Title - Sujet Victoria SAR Station Construction	
Solicitation No. - N° de l'invitation F1700-184521/A	Amendment No. - N° modif. 005
Client Reference No. - N° de référence du client	Date 2019-02-25
GETS Reference No. - N° de référence de SEAG PW-\$PWY-039-8541	
File No. - N° de dossier PWY-8-41217 (039)	CCC No./N° CCC - FMS No./N° VME
Solicitation Closes - L'invitation prend fin at - à 02:00 PM on - le 2019-03-04	Time Zone Fuseau horaire Pacific Standard Time PST
F.O.B. - F.A.B. Plant-Usine: <input type="checkbox"/> Destination: <input checked="" type="checkbox"/> Other-Autre: <input type="checkbox"/>	
Address Enquiries to: - Adresser toutes questions à: Park (PWY), Isabell	Buyer Id - Id de l'acheteur pwy039
Telephone No. - N° de téléphone (604) 365-0073 ()	FAX No. - N° de FAX (604) 775-9381
Destination - of Goods, Services, and Construction: Destination - des biens, services et construction: DFO - Search and Rescue Station - Victoria, BC

Amendment 004

1. to extend the closing date; and,
2. to publish the Addendum #4.

*The following changes in the Tender Documents are effective IMMEDIATELY.
This addendum will form part of the Contract Documents*

9
A7.03

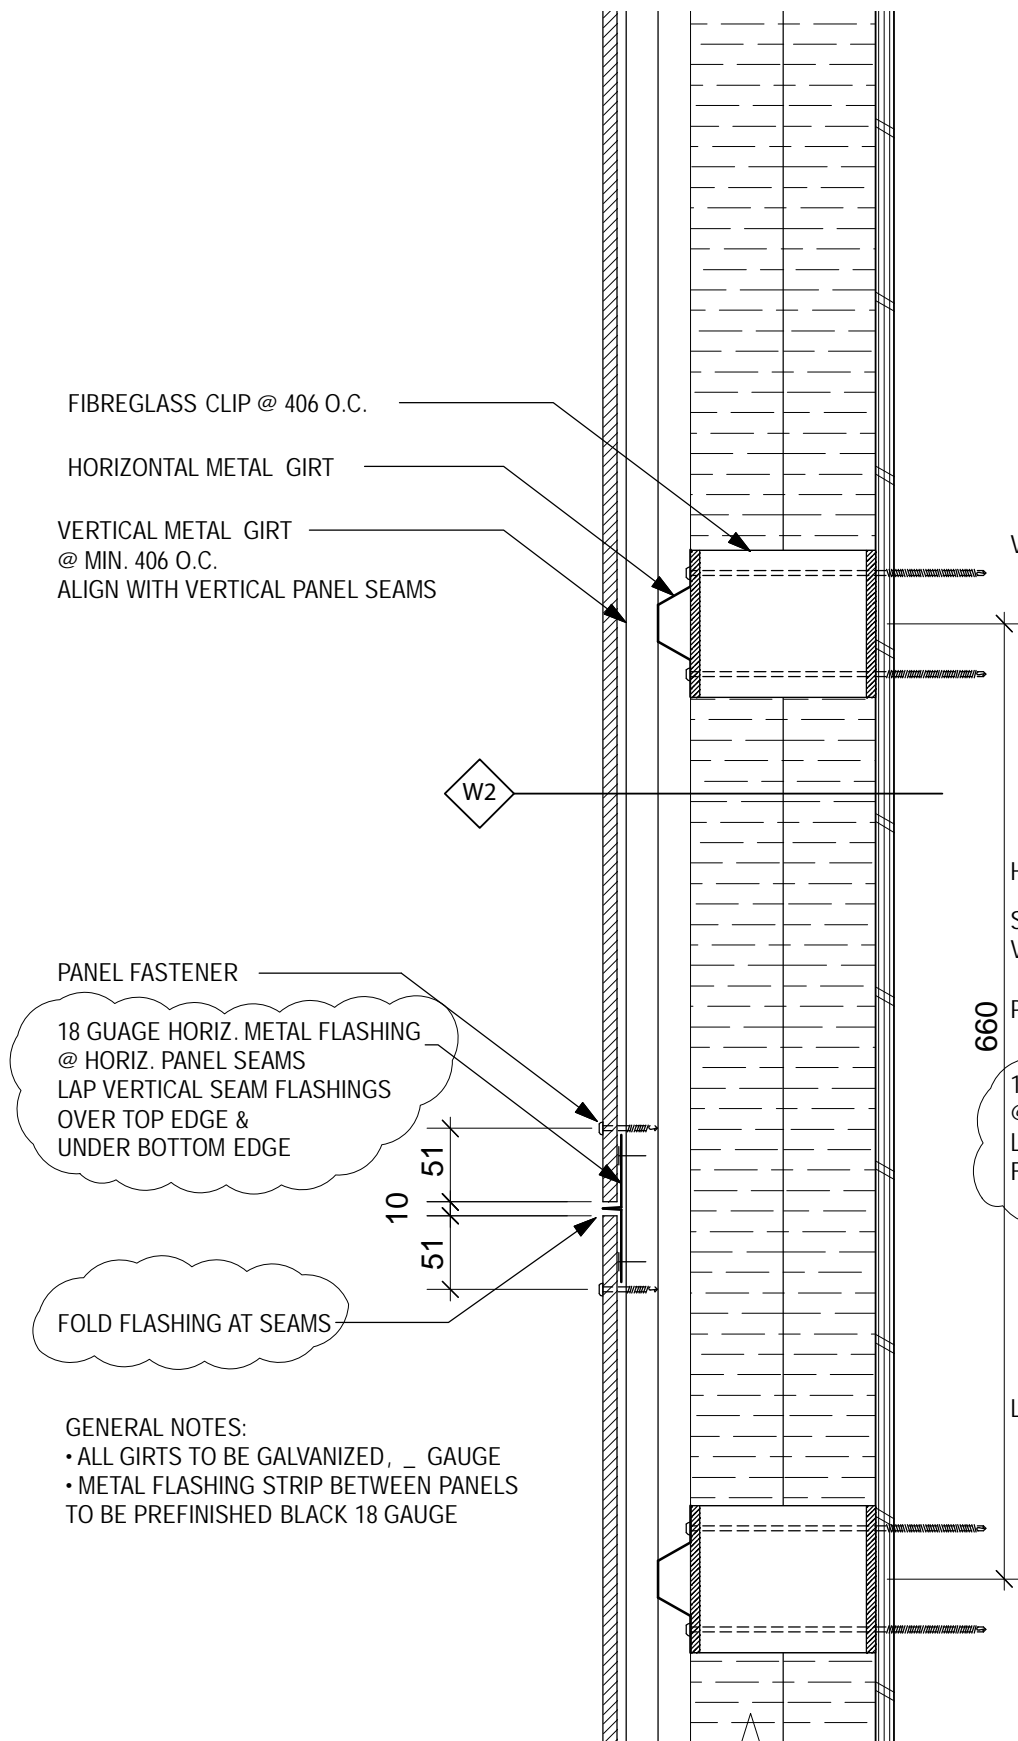
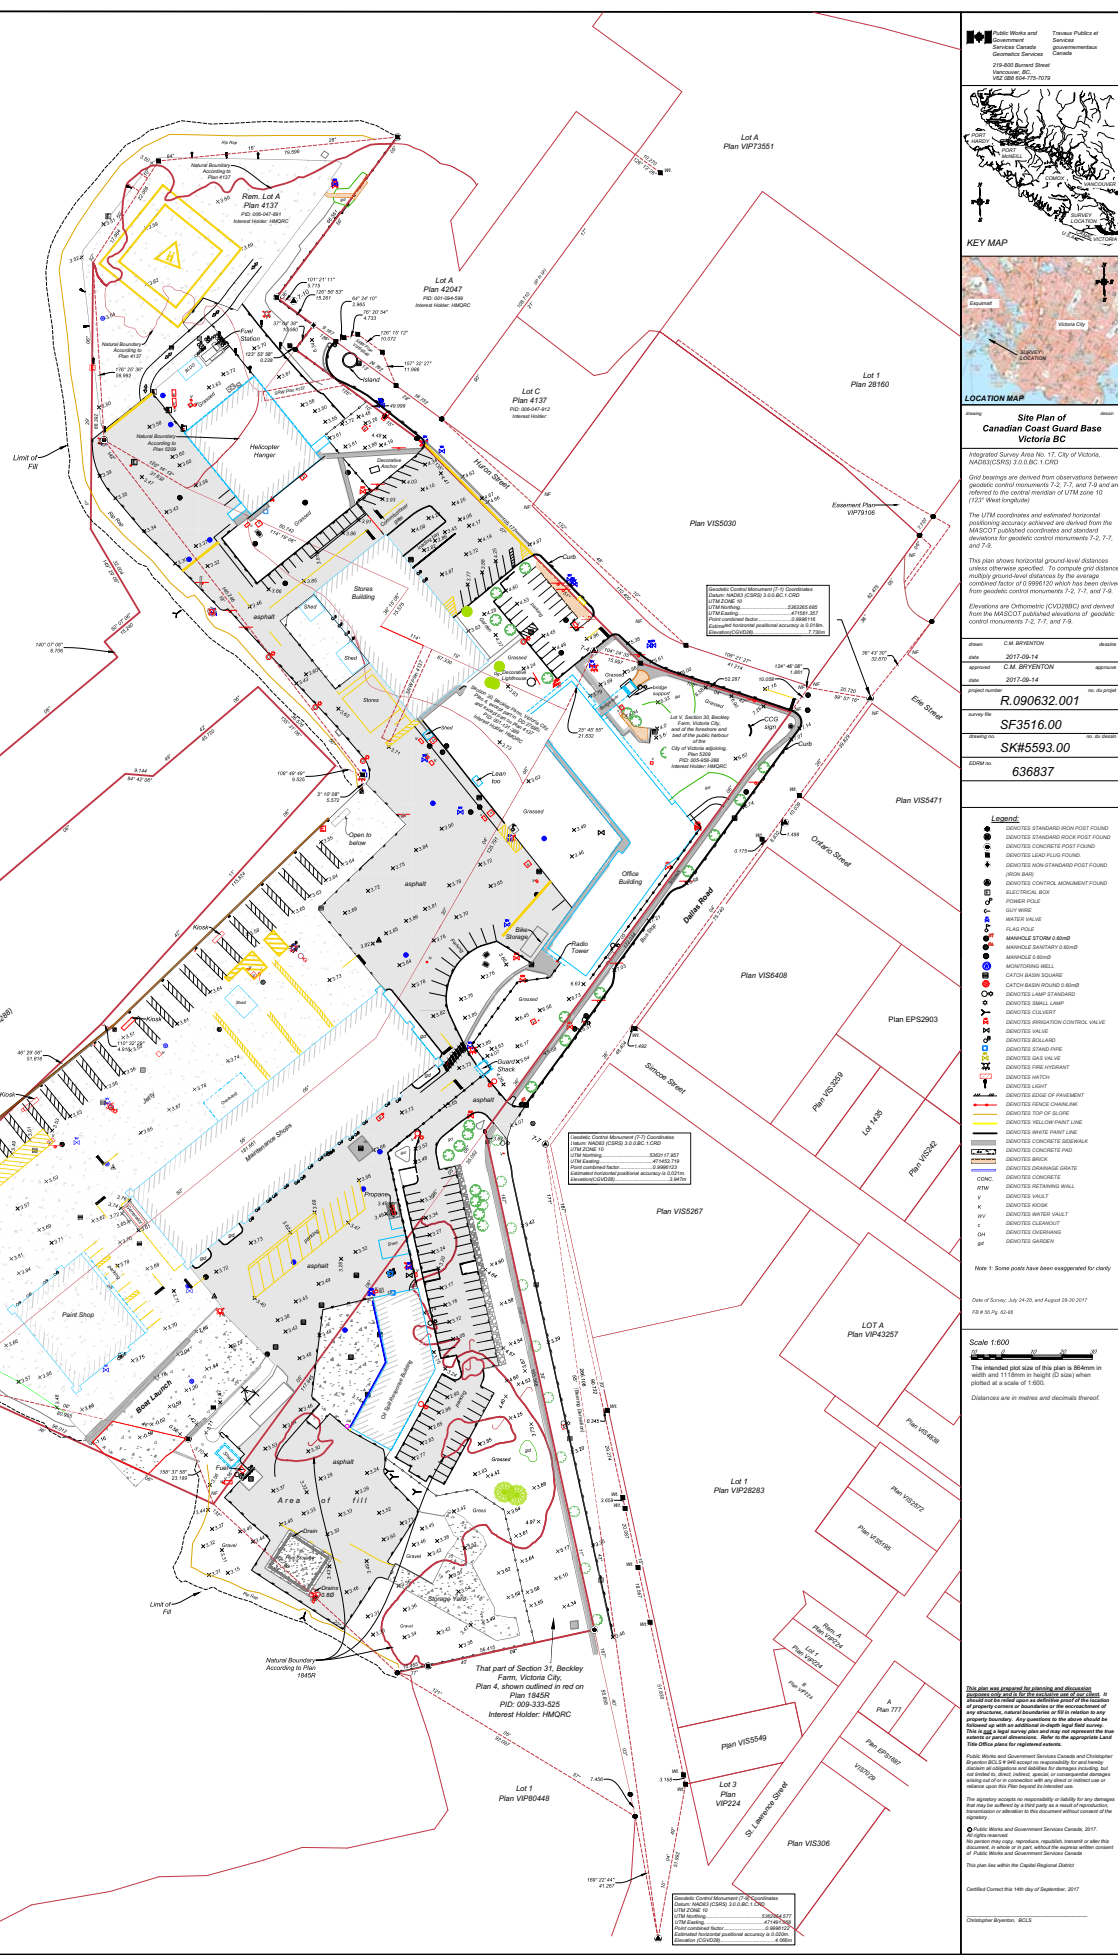
6. Drawing A7.03

See attached revised details 9 & 10. Revisions to notes bubbled.

Date of Survey: July 24-25, and August 28-30 2017

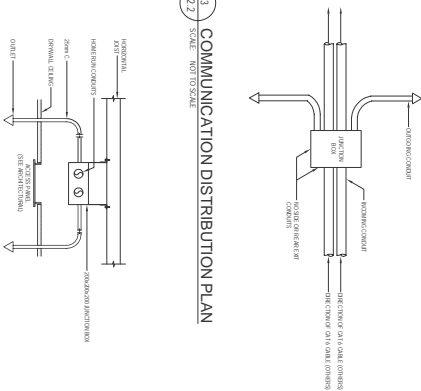
Find attached site survey plan noted in response.

5 COMMUNICATION JUNCTION BOX DETAILS
E2.2 SCALE: NOT TO SCALE

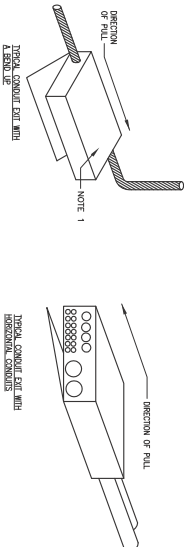
1. Drawing E2.2 (see attached)

Notes 1 -3 for detail 5/ E2.2, clarified.

- NOTES:
- CONDUITS SHALL ONLY EXIT IN THE DIRECTION OF THE PULL. CONDUITS SHALL NEVER EXIT THE BOX, SITS OR TOP OF A PULL BOX. CONDUIT ENDS SHALL BE ALIGNED.
 - CONDUIT JUNCTION BOXES COMMUNICATION RISE UP TO THREE RISES COMMUNICATION OUTLET. 300mm x 300mm x 300mm DEEP FOR REMAINING JUNCTION COMMUNICATIONS BOXES.
 - CONDUIT JUNCTION BOXES - TELEPHONE 200mm x 200mm x 150mm DEEP
